# Product Safety Recall

## N182204190 Chassis Cab Truck Fuel Leak

**Revision:** 02

**Revision Description:** This bulletin has been revised in the Parts, Warranty Information, and Service Procedure sections. The correction statement has also been updated to capture these changes. Please discard all previous versions of N18220419.

4916360

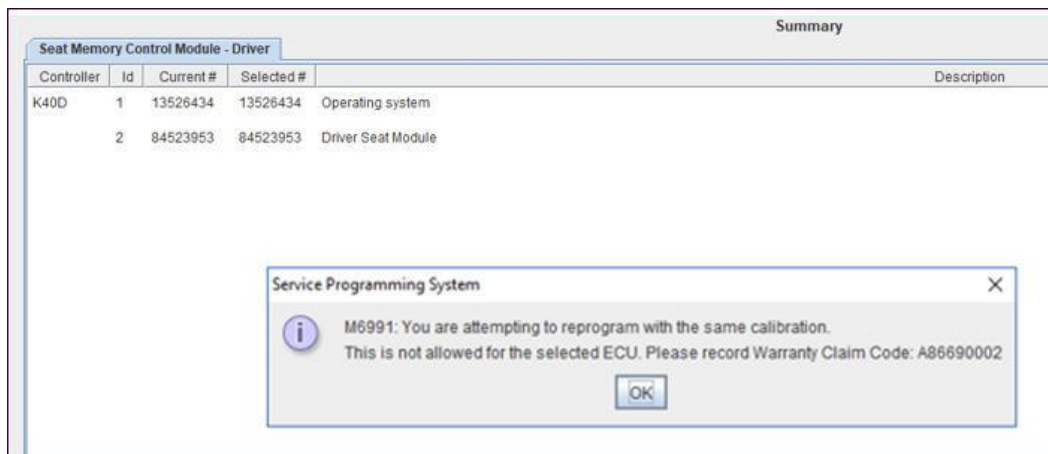
2. Inspect the front fuel tank shield for contact with the propeller shaft universal joint, as shown above.
  - If there is evidence of the propeller shaft universal joint contacting the shield, proceed to the next step

- If there has not been any contact, proceed directly to step 7.
3. Remove the fuel tank shield. Refer to *Fuel Tank Shield Replacement* in SI.
  4. Inspect the front fuel tank for evidence of the propeller shaft universal joint contact.

- If there is NO evidence of the propeller shaft universal joint contacting the front fuel tank, proceed to the next step.
    - If there is evidence of the propeller shaft universal joint contacting the front fuel tank, replace the front fuel tank. Refer to *Fuel Tank Replacement (Cab/Chassis – Front)*.

5. Replace the front fuel tank fuel level sensor. Refer to *Fuel Level Sensor Replacement (25/35 Series)*.
  6. Replace the fuel tank shield. Refer to *Fuel Tank Shield Replacement* in SI.
